Re: Alfreda Drive
Stormwater Review

Meyers Engineering, PLLC was requested by Harnett County Development Services to review a storm drainage situation between properties on Alfreda Drive in southwest Harnett County. The following is a summary of the existing situation as I understand it, my research, findings, and my conclusions.

Exhibit 1

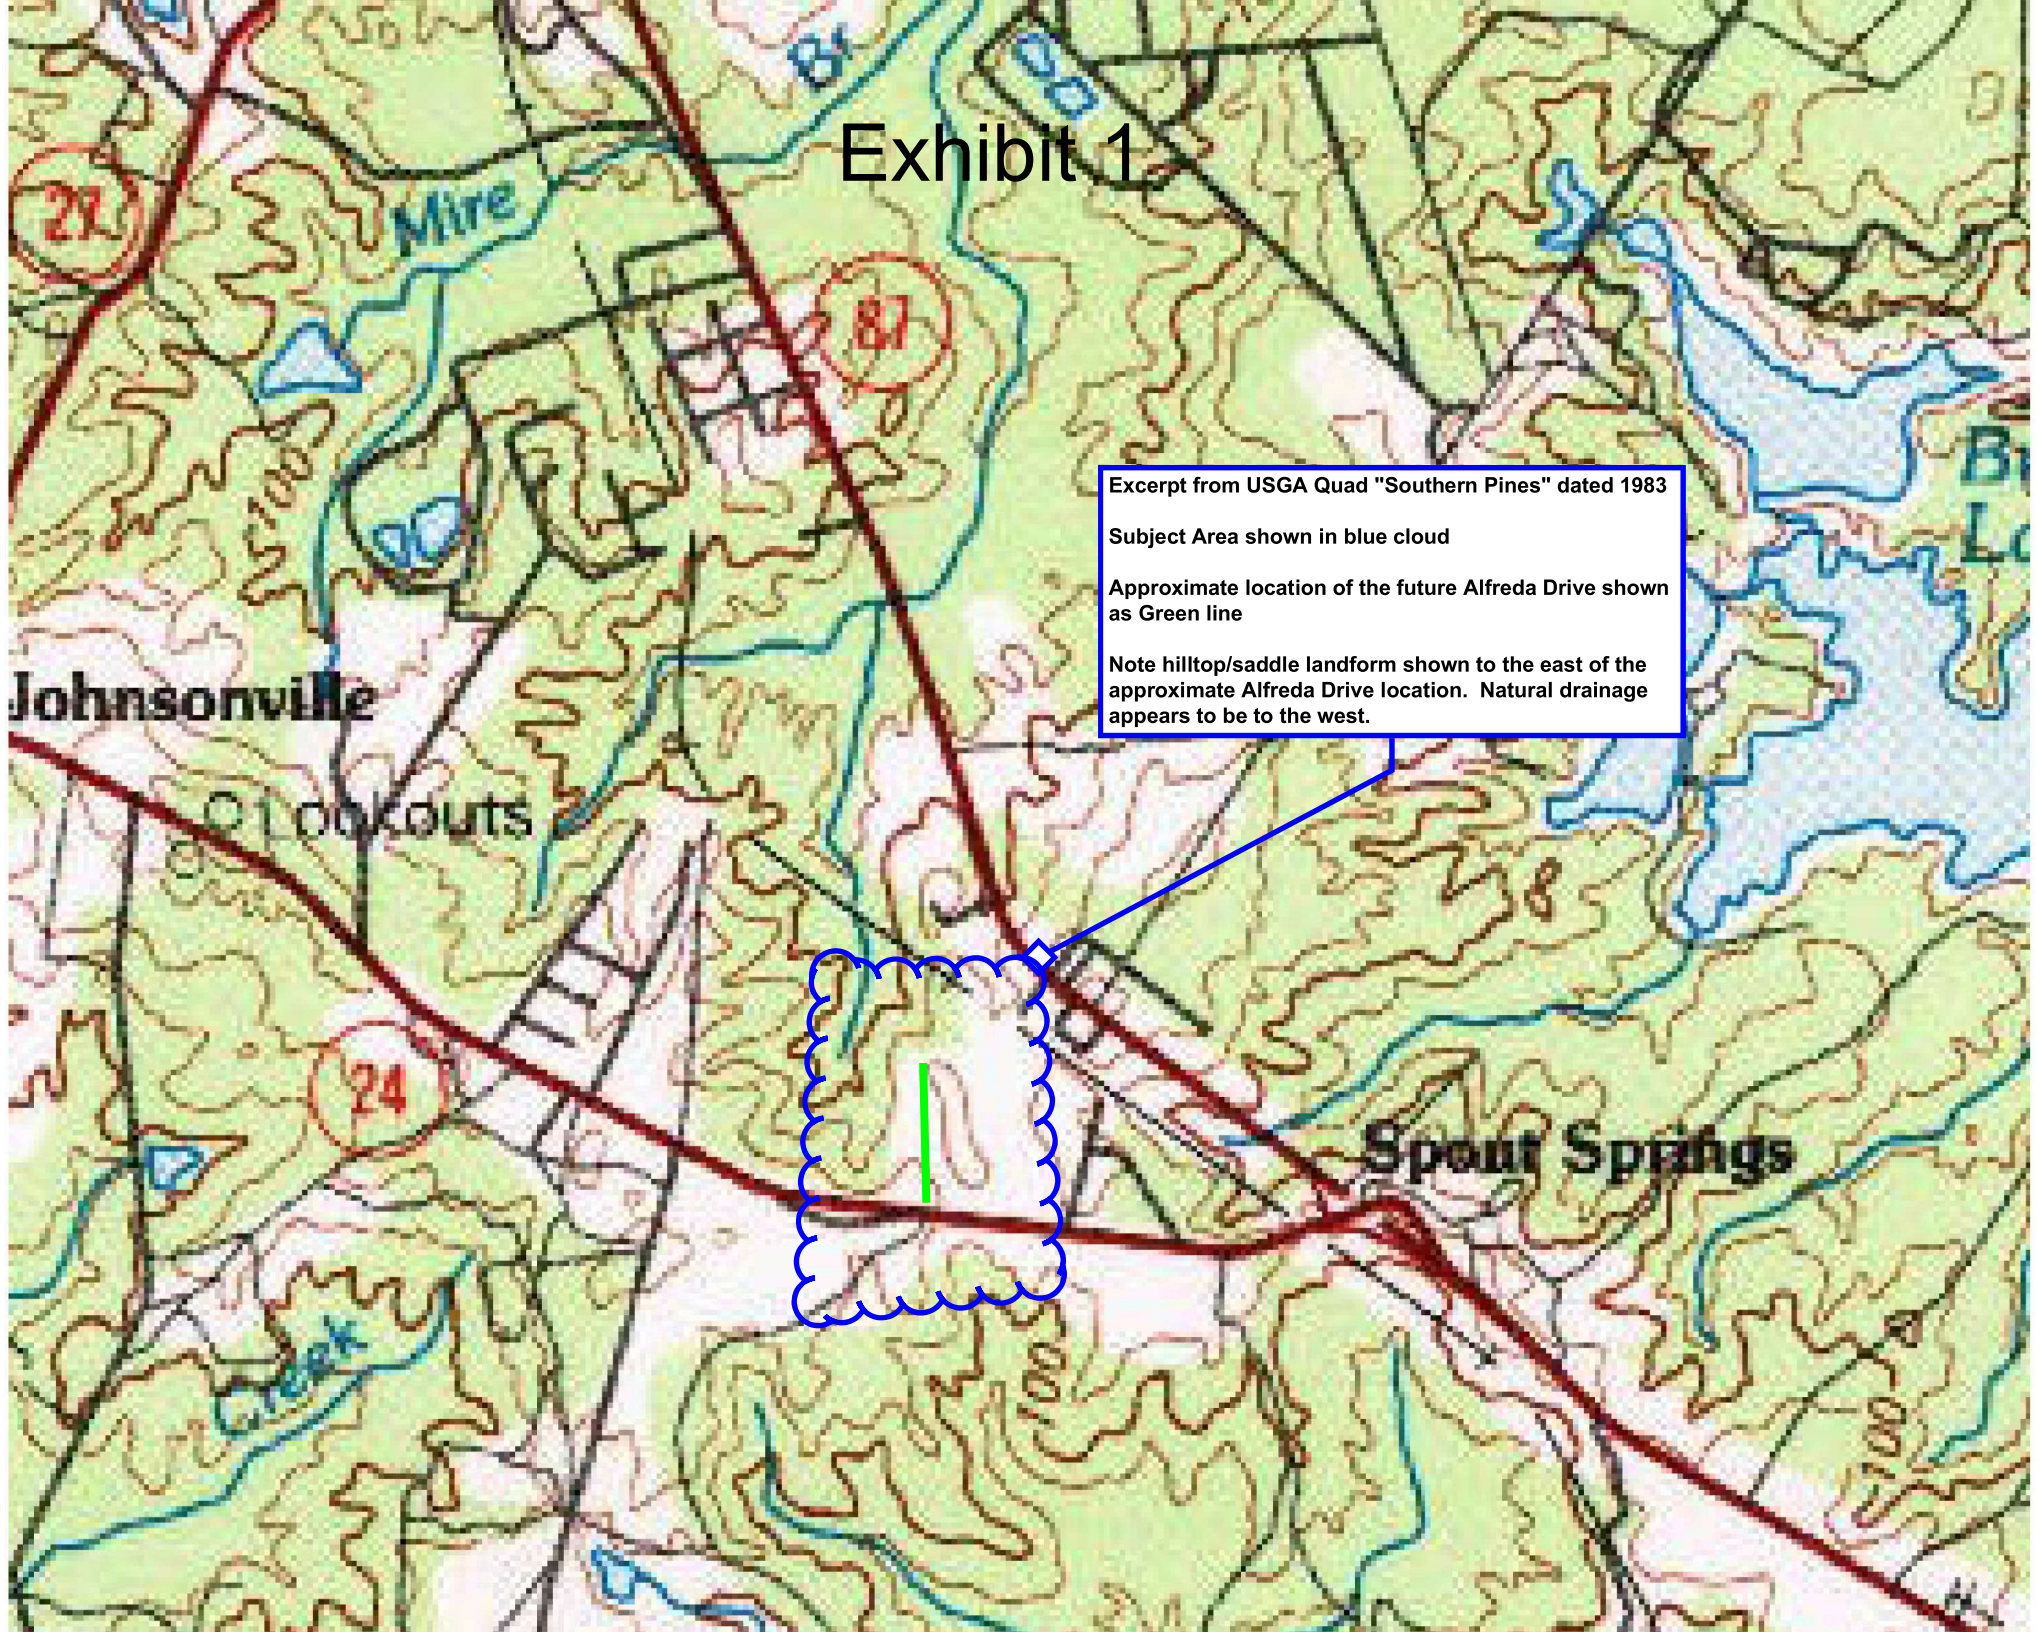
1. 1983 USGS Southern Pines Map (Exhibit 1)
 - a. Based on review of the 1983 USGS map, 2 hilltops to the east of Alfreda Drive form a saddle landform resulting in a drainage path flowing from east to west. This would mean that prior to the existence of Alfreda Drive, stormwater runoff would flow to the blue line stream west of Alfreda Drive.

Note hilltop/saddle landform shown to the east of the approximate Alfreda Drive location. Natural drainage appears to be to the west.

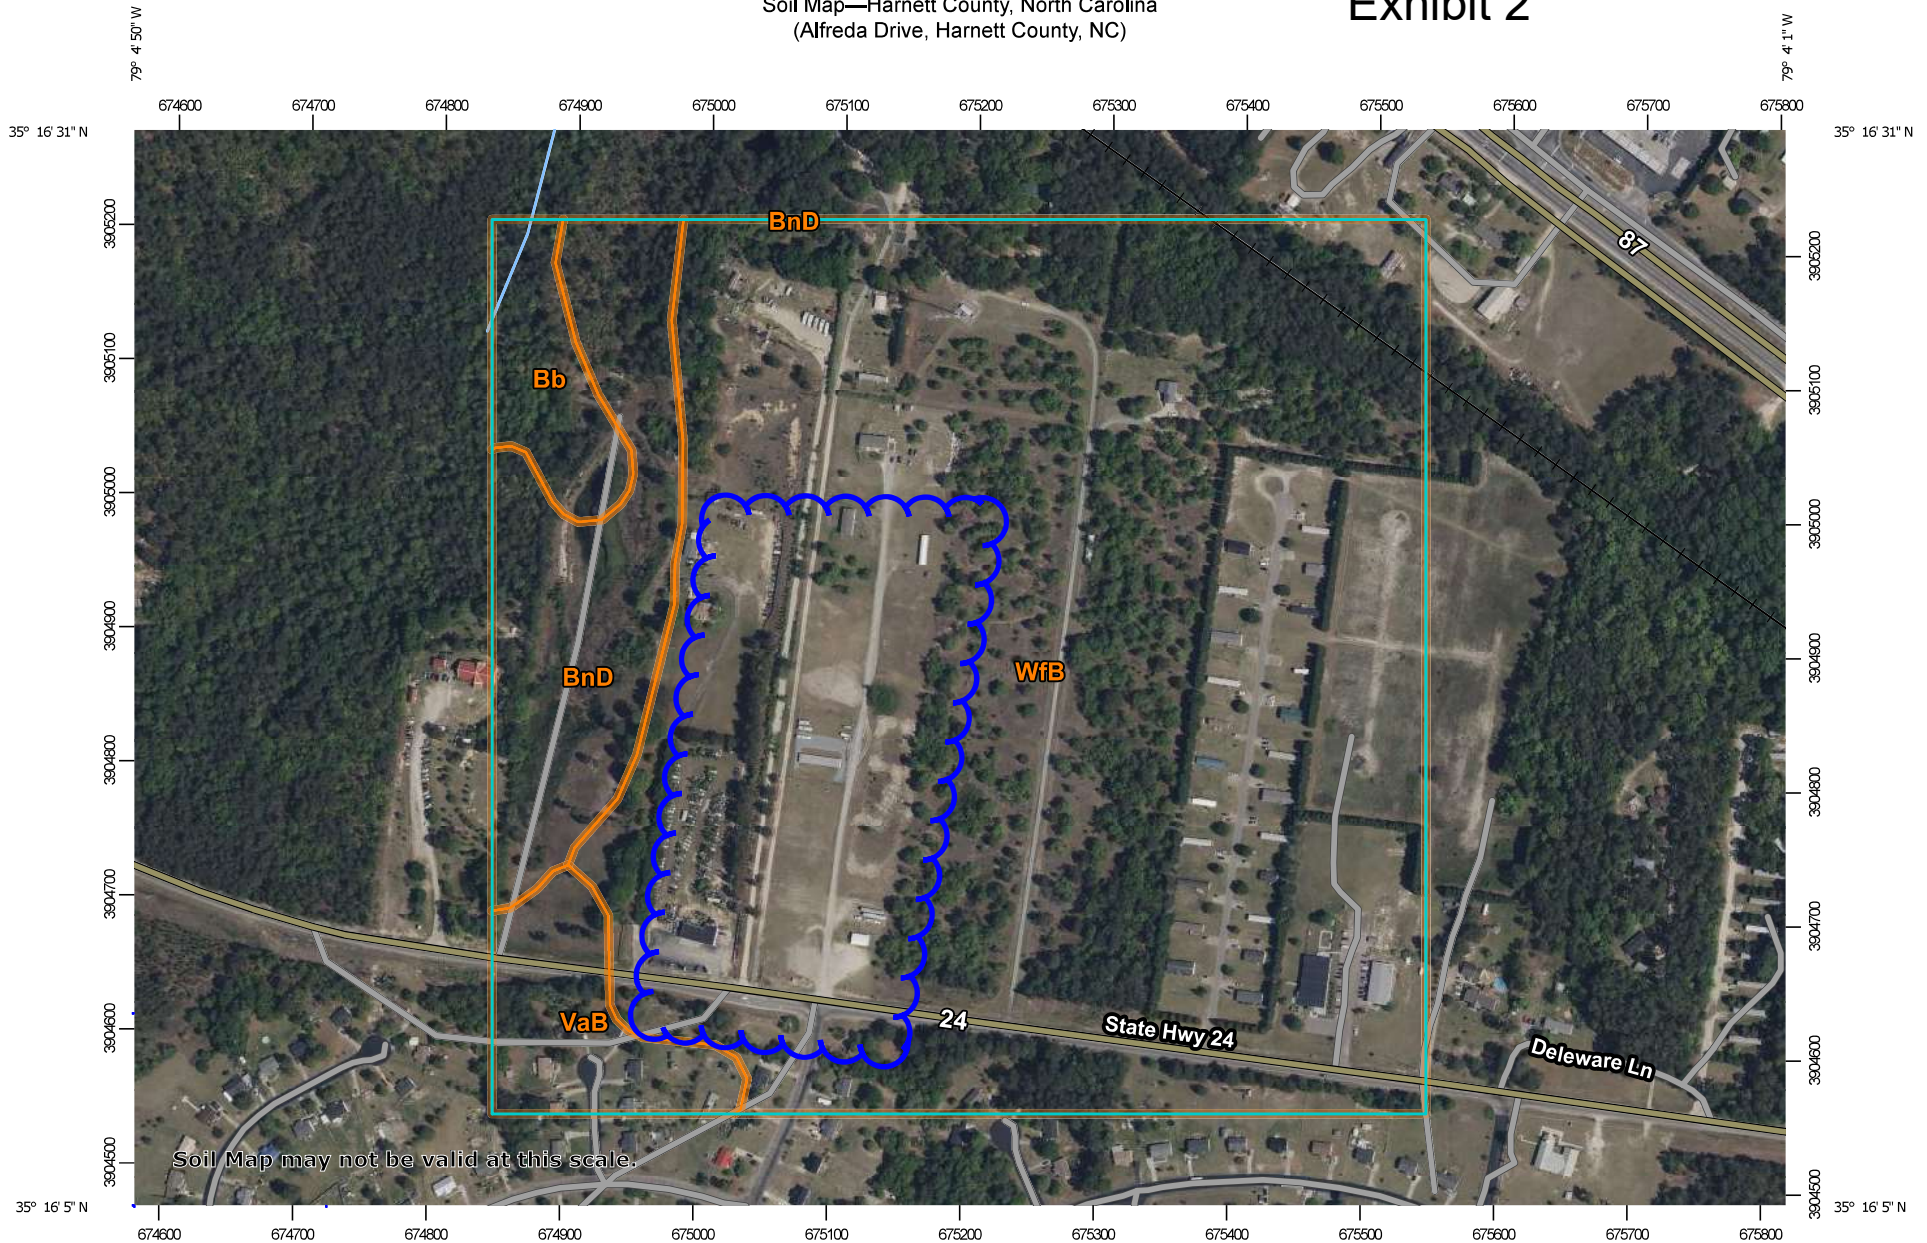
2. USDA Soils Map (Exhibit 2)
 - a. Area soils in the subject area predominantly Wakula sand (WfB), 0 to 8% slope.
 - b. USDA description of Wakula sand states it's a sandy and loamy marine deposits and/or eolian sands that are somewhat excessively drained in a very low runoff class with high to very transmission of water. The description also states that frequency of flooding and ponding is "none". The soil hydrological group is A, which USDA defines as "Soils in this group have low runoff potential when thoroughly wet. Water is transmitted freely through the soil." (USDA National Engineering Handbook, Part 630 Hydrology, Chapter 7 Hydrological Soil Groups, 2009)

2005 Aerial Image from Harnett County GIS

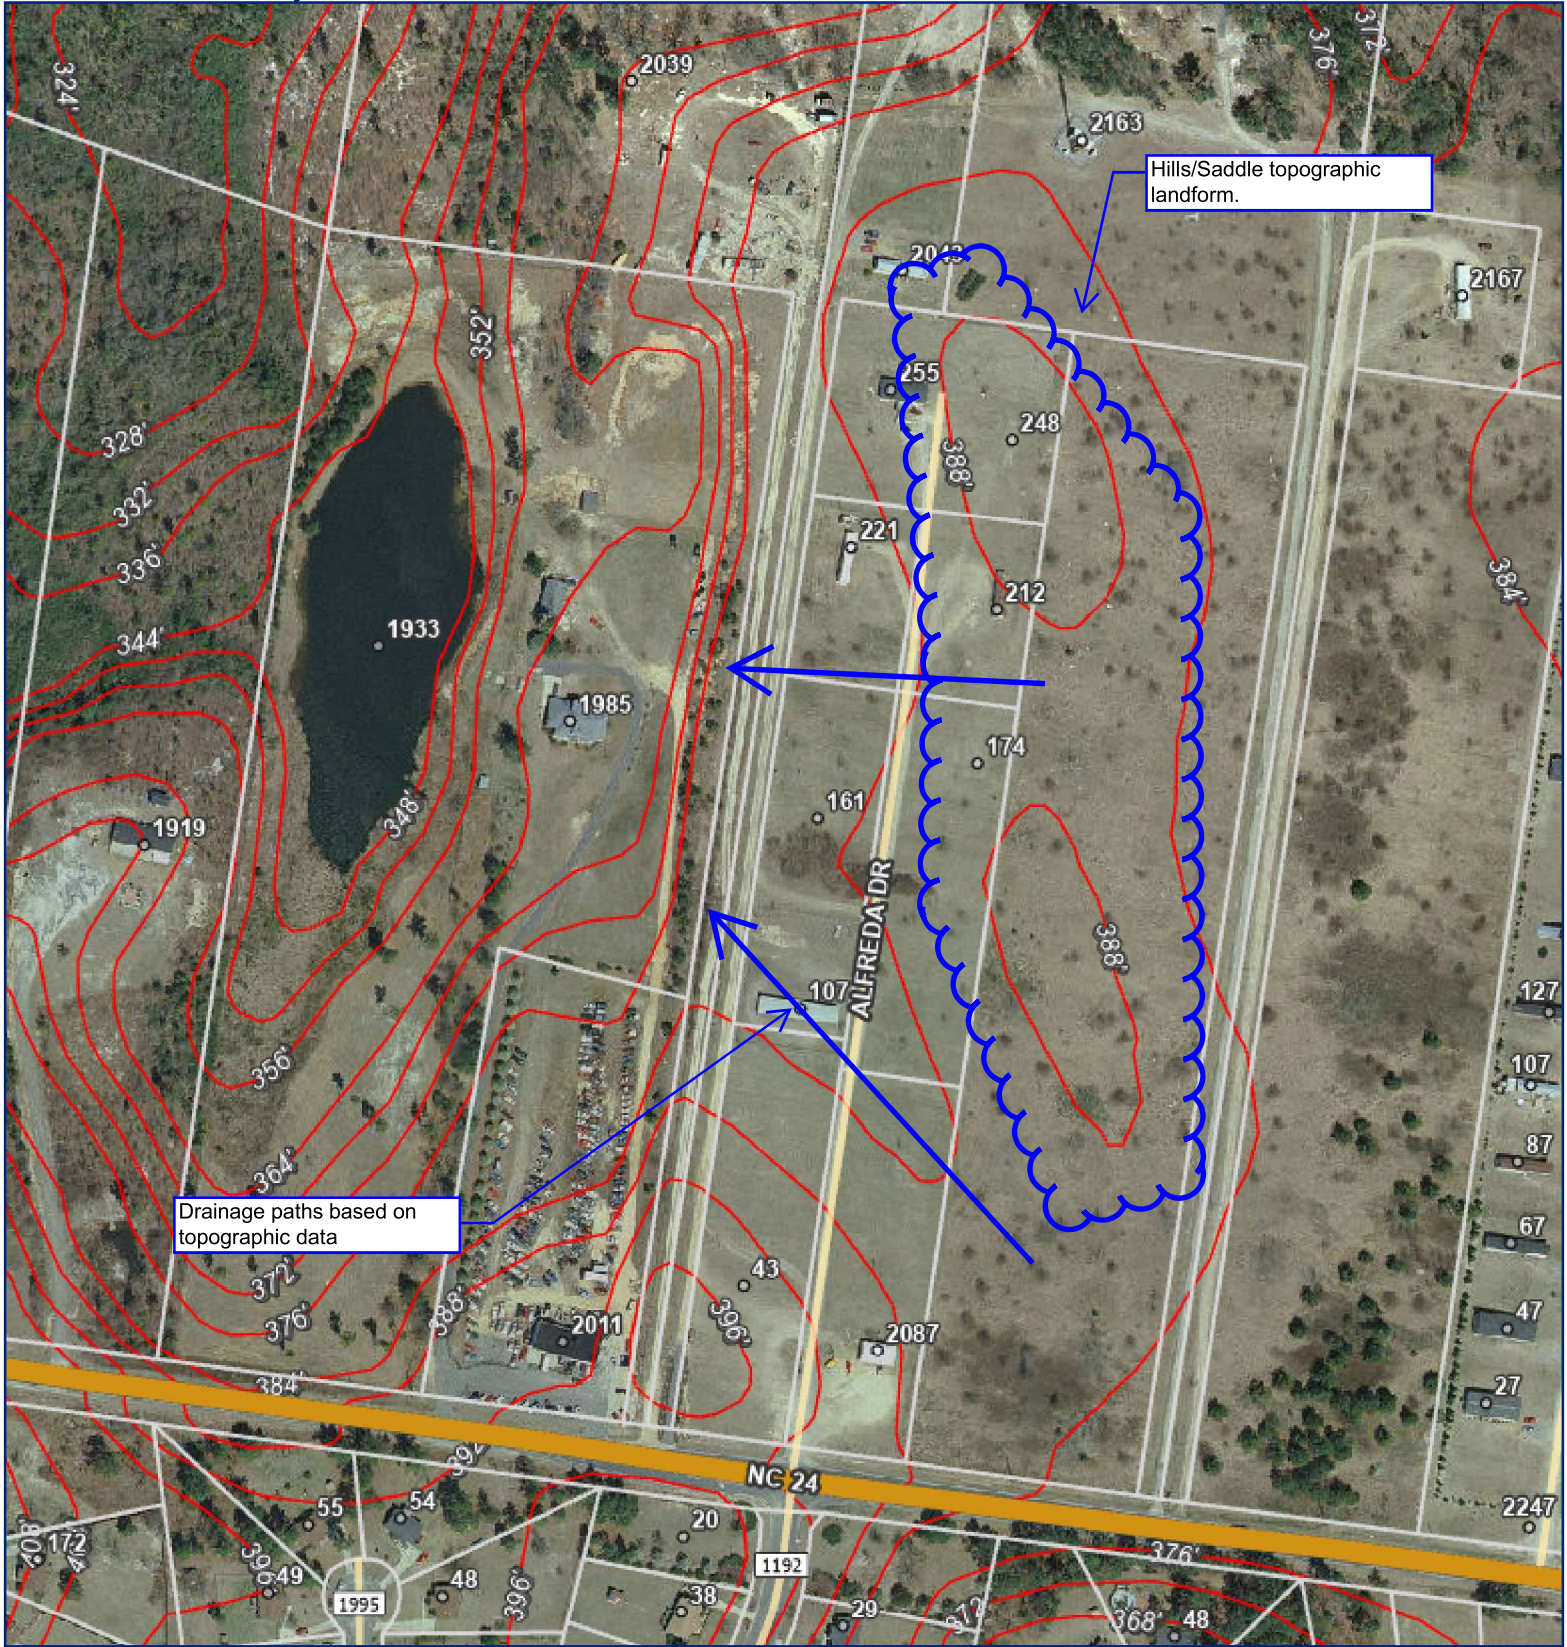
3. 2005 Aerial from Harnett County GIS (Exhibit 3)
 - a. The GIS topographic data illustrates the saddle landform similar to the 1983 USGS map.
 - b. The 2005 aerial illustrates Alfreda Drive and the storage unit building constructed on 107 Alfreda Drive.

- c. It appears the storage unit building with the corresponding grading was located in the natural drainage path.
 - d. Based on the site visit in 2026, Alfreda was constructed without a storm drainage pipe.

Note that the natural drainage path may have been impacted by the construction of the original storage building at 107 Alfreda Drive.

2021 Aerial Image form Harnett County GIS

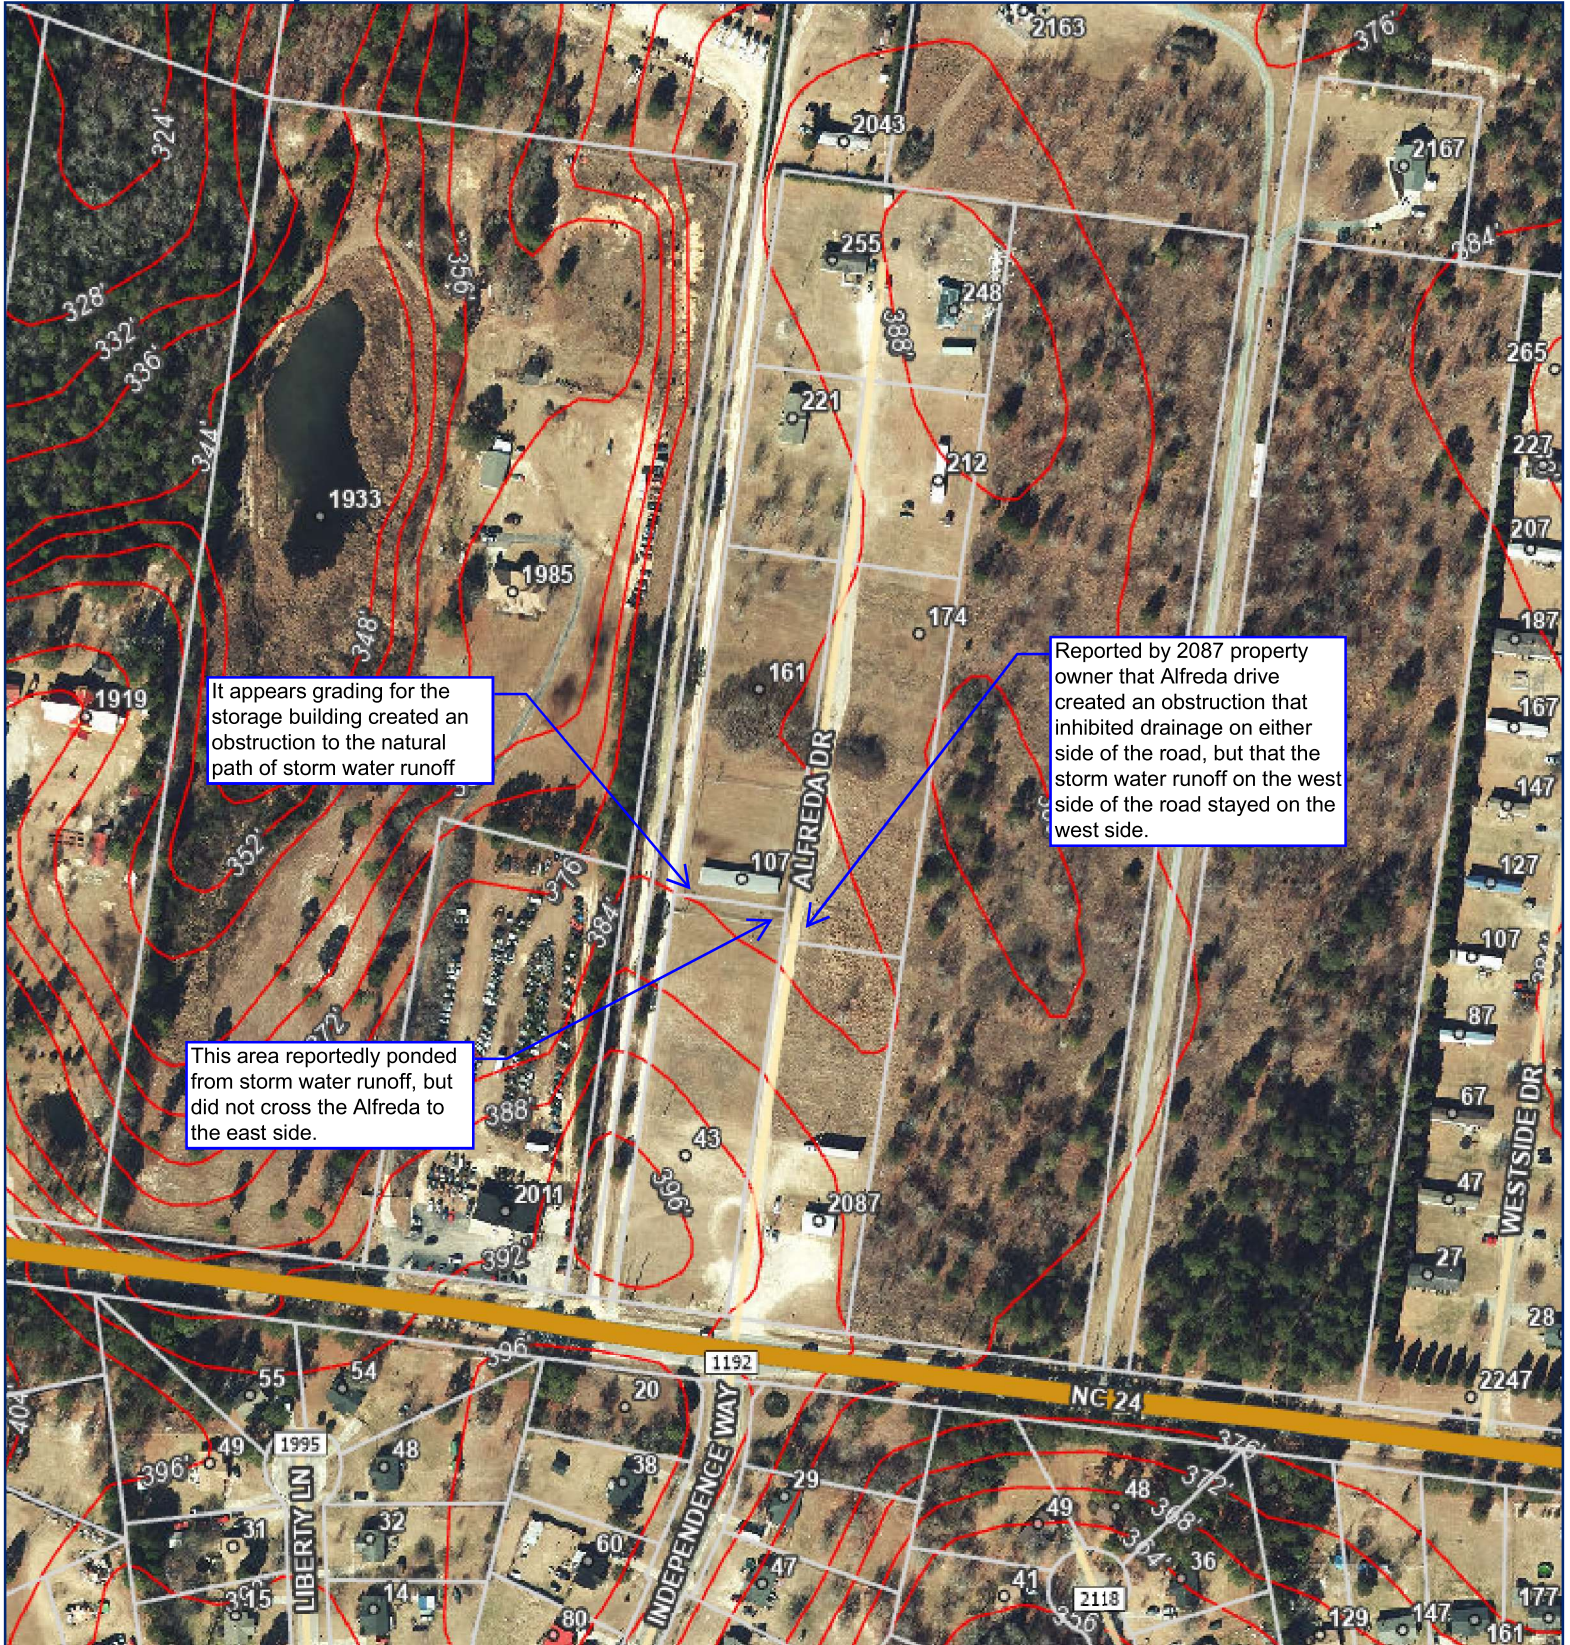
4. 2021 Aerial from Harnett County GIS (Exhibit 4)
 - a. Substantially the same conditions as the 2005 aerial.
 - b. Mr. Graham would have owned his properties since 2016 at this point without issue.

- c. About this time Anderson Creek Rentals and Properties LLC purchased the 43 Alfreda Drive/107 Alfreda Drive properties.
5. 2024+/- Aerial from Harnett County GIS (Exhibit 5)
